Project	IEEE 802.16 Broadband Wireless Access Working Group < http://ieee802.org/16 >	
Title	consolidation text in general	
Date Submitted	2006-04-30	
Source(s)	Jim Carlo, Wu Xuyong, Huawei Huawei Industrial Base, Bantian, Longgang, Shenzhen 518129 P.R.C	Voice: +86-755-28972324 Fax: +86-755-28975523 J.carlo@ieee.org ; wuxuyong@huawei.com
Re:	80216h-06_011: Working Group Review: P802.16h Working Document (2006-04-07)	
Abstract	Some consolidation text in General description for the working document	
Purpose	To introduce the basic component and basic relationship at the front of the WD.	
Notice	This document has been prepared to assist IEEE 802.16. It is offered as a basis for discussion and is not binding on the contributing individual(s) or organization(s). The material in this document is subject to change in form and content after further study. The contributor(s) reserve(s) the right to add, amend or withdraw material contained herein.

consolidation text in general
Huawei Technologies Co., Ltd.

Proposed text changes

figure hxx. neighbor relationship formed by bidirectional interference

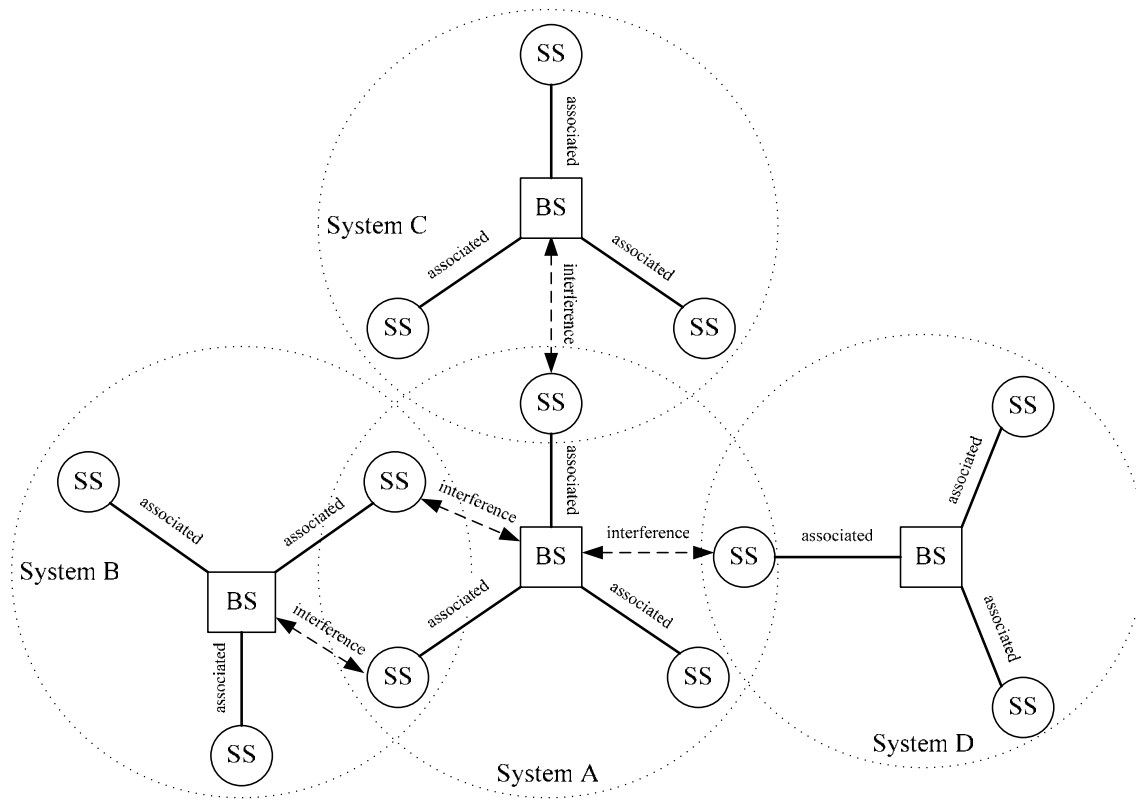
The figure hxx shows some examples of neighbor relationship formed by bidirectional interference. In the figure hxx, system A have neighbor relationship with system B, system C and system D, vice versa, system B have neighbor relationship with system A, so do system C and system D.

figure hxx. neighbor relationship formed by unidirectional interference

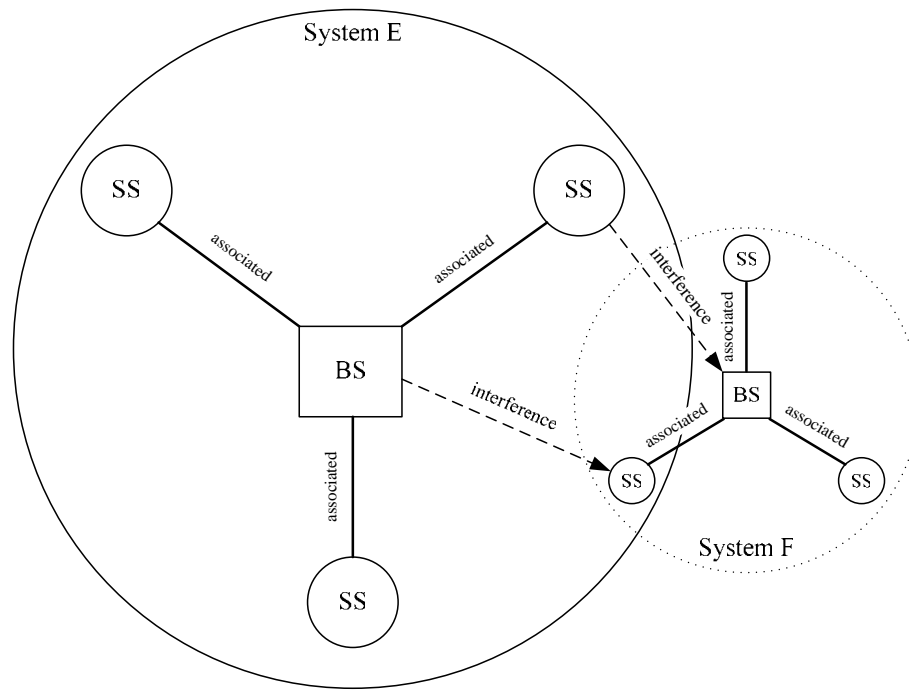
The figure hxx is an example of neighbor relationship formed by unidirectional interference., system E and system F have neighbor relationship with each other, although all the interference between the two systems is caused by system E. The interference from the SSs in one system to the SSs in another system, and from the BS in one system to the BS in another system is ignored, for the reason that they have been avoid by transmit/receive synchronization.

figure hxx. concept of neighborhood

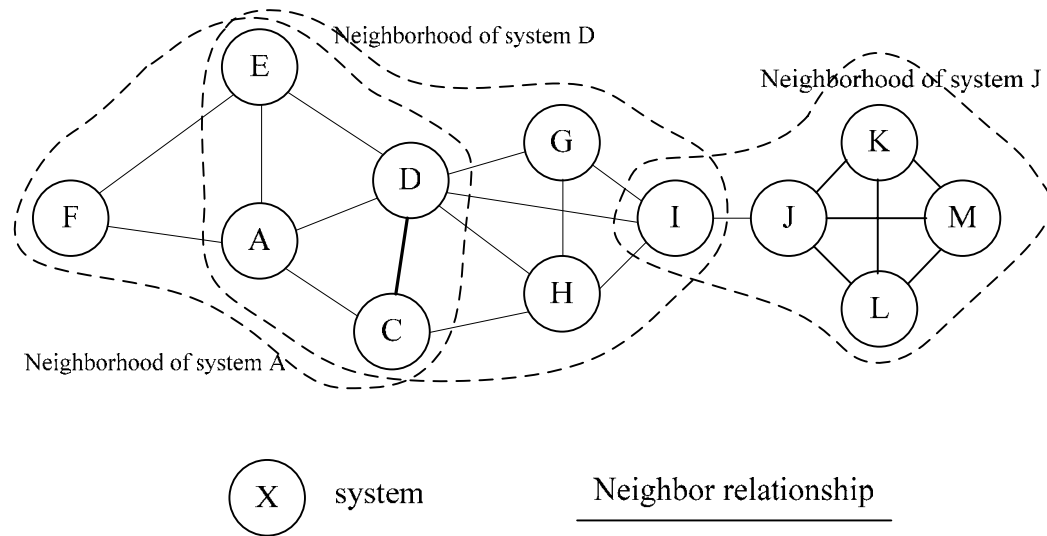
Interference Neighborhood: Interference neighborhood is relative to a system. A system will perceive as interference neighbors, all other systems which create/receive interference to/from it. The figure hxx shows some examples of neighborhood.
